Planning and Development Services Division Vote Report

Meeting Date: January 23, 2017

Petition: **P.Z. 05-2016 Wildhorse Baxter Center, C148B (Shelbourne Senior Living):**
A request for a zoning map amendment from a “C-8” Planned Commercial District to a “UC” Urban Core District for 5.21 acres located south of Wild Horse Creek Road and east of its intersection with Baxter Road (18T630283).

PRELIMINARY DEVELOPMENT PLAN
 REVISED 5-12-2016
 04-05-2016
 P2

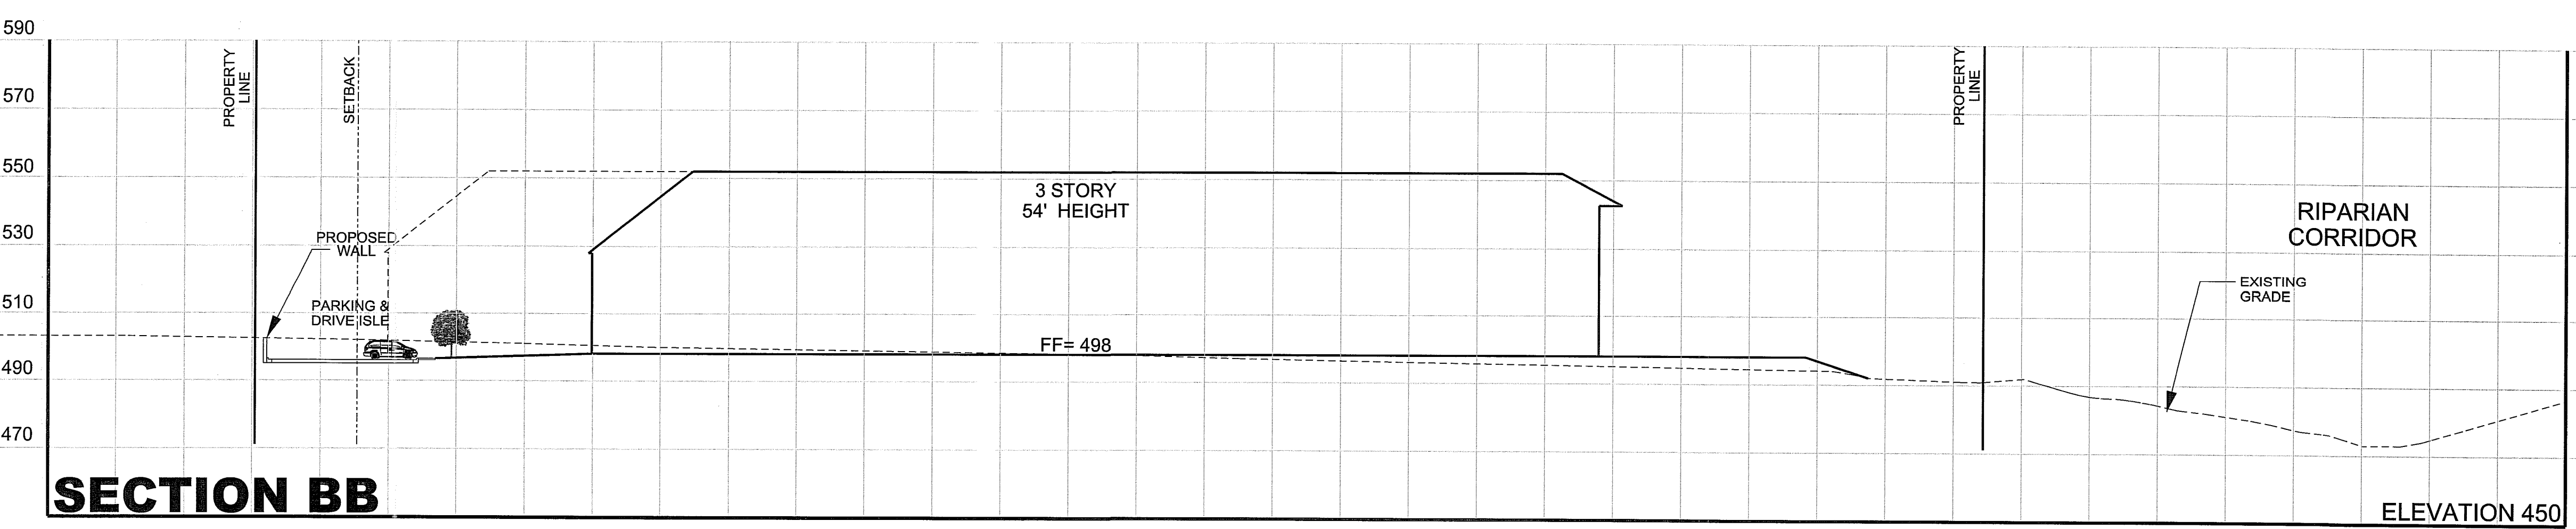
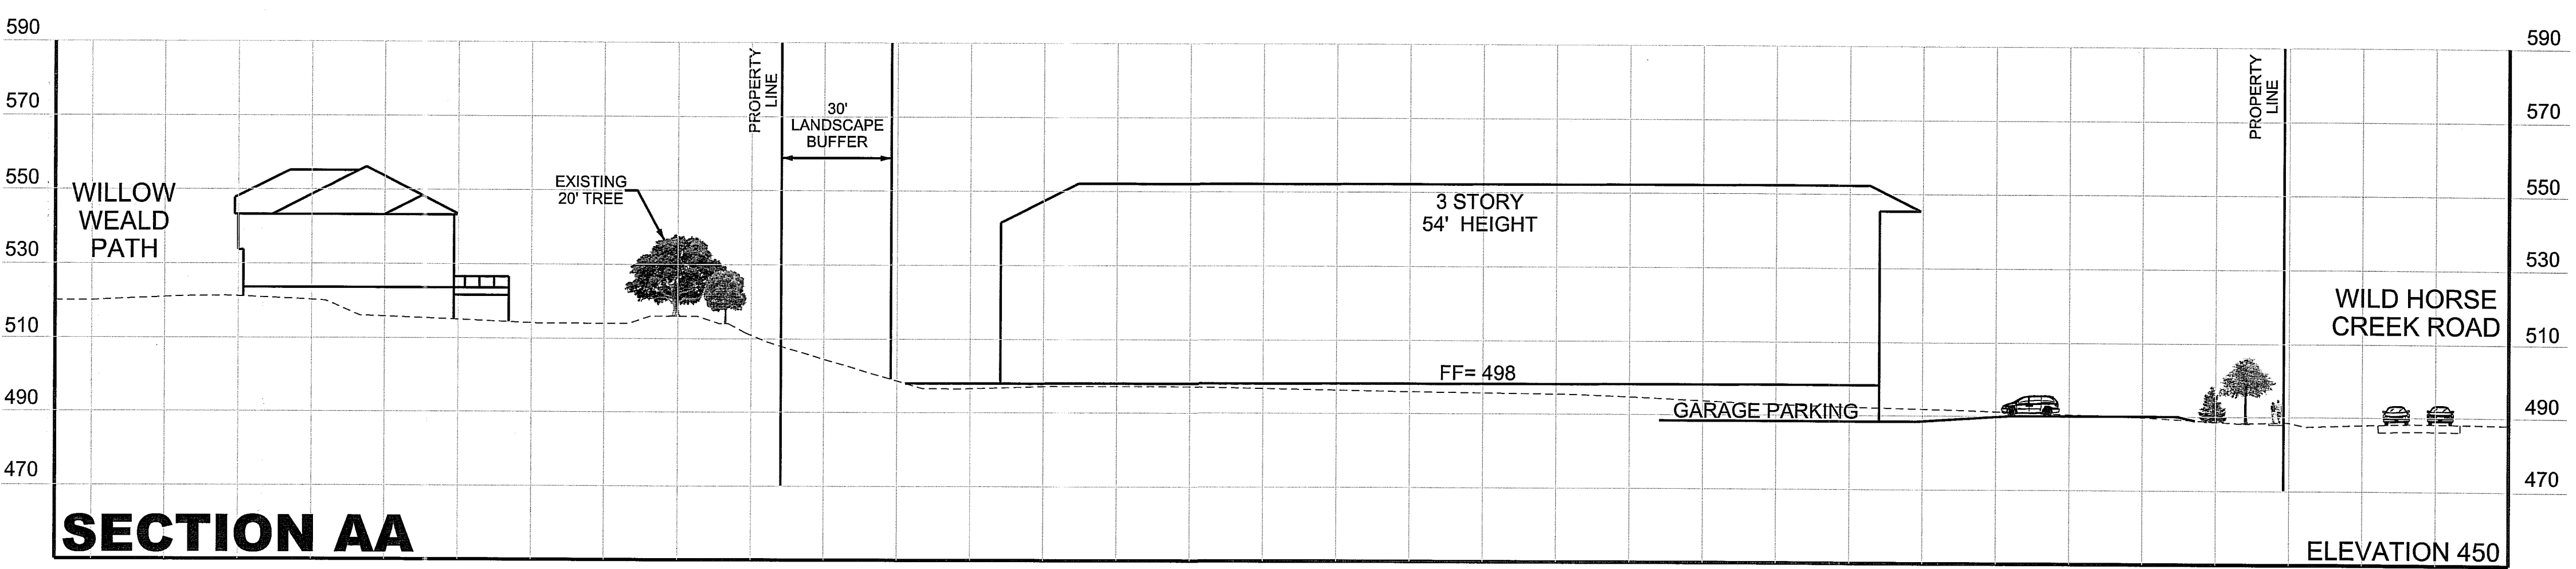
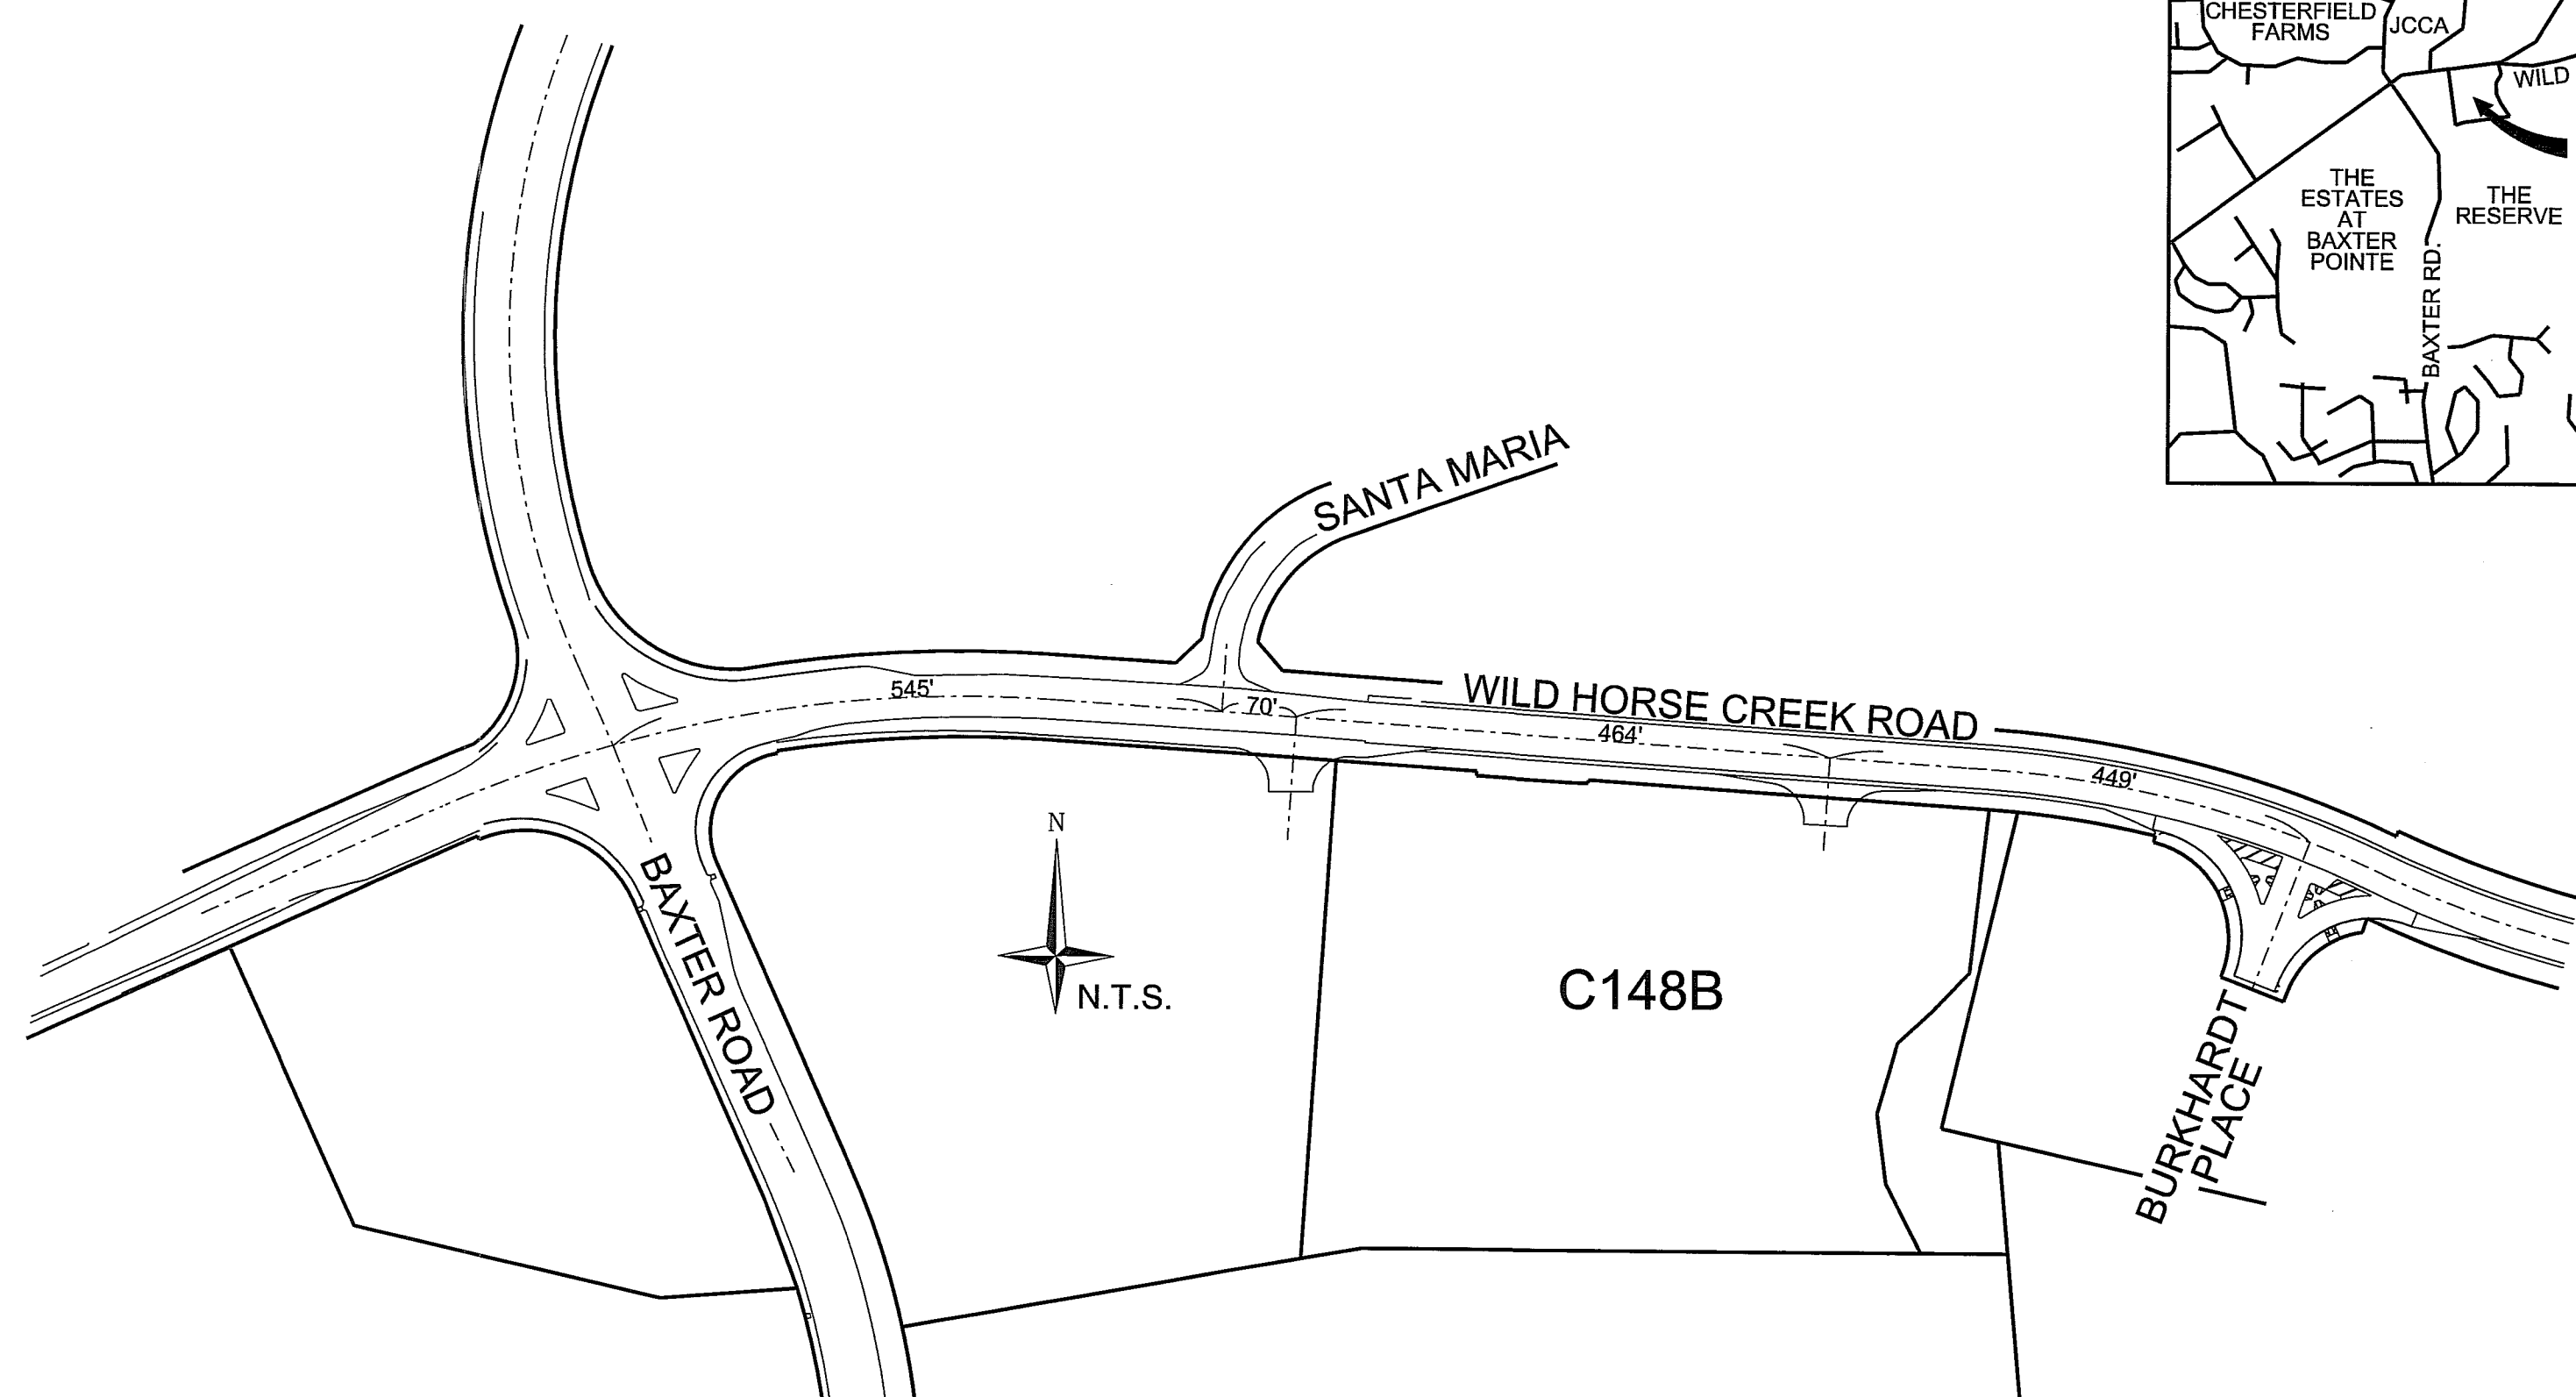
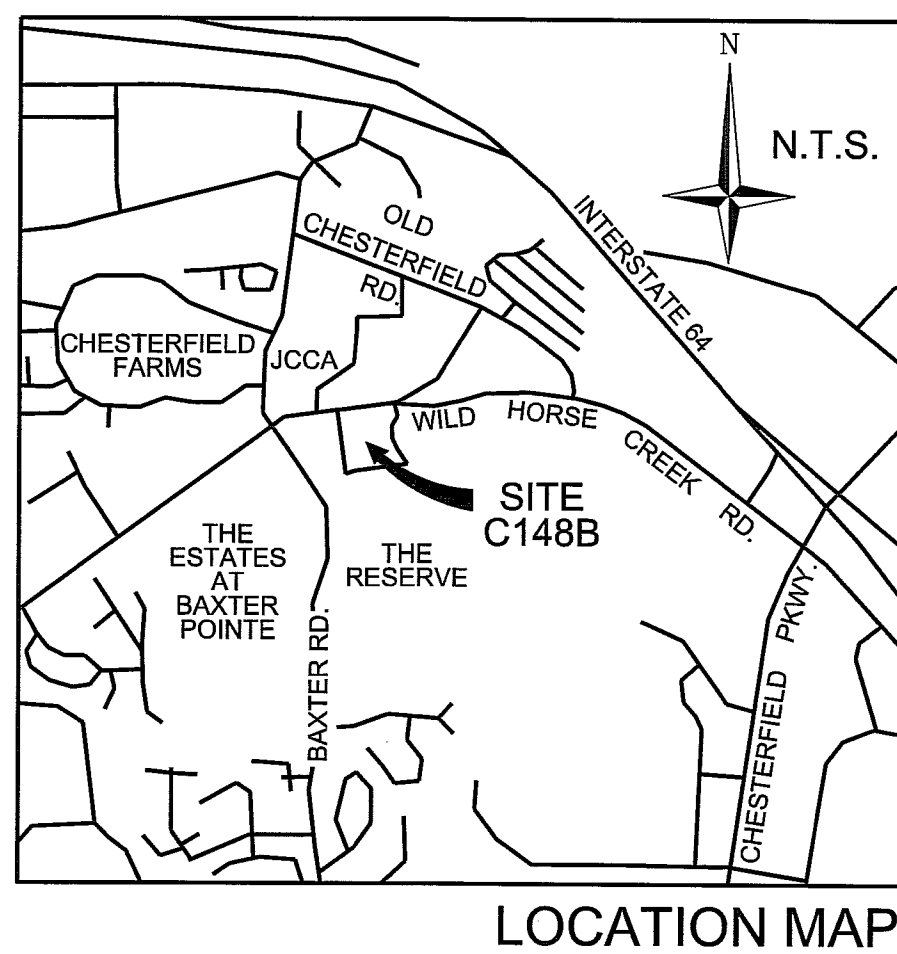
3. Concerns were expressed regarding the proposed height of the facility – specifically the four story portions of the building. Clarify the Preliminary Plan to clearly reflect the location of 3-

story sections versus 4-story sections of the building and consider revising the proposal to eliminate any 4-story portions of the building.

6. The proposed off-site access location does not comply with access management standards. A restriction preventing use of this driveway location until such time as the access is brought into compliance with City and County access management standards will be included in the Attachment 'A' for the development.

The applicant has modified the plan to remove the four story section of the building and the Attachment 'A' includes a restriction on a maximum of three stories. In order to reduce the building height, the Petitioner has included a request to reduce the minimum setback on the western perimeter of the development (vacant commercial zoned property). The property owner of the adjacent parcel is agreeable to the change and is currently the land owner of the subject site of this report.

The Petitioner has agreed to relocate the proposed drive location into a compliant condition by aligning the location with Santa Maria Dr.

The Preliminary Plan has been revised to relocate the shared access drive on the parcel to the west in conformance with the City’s access management requirements.
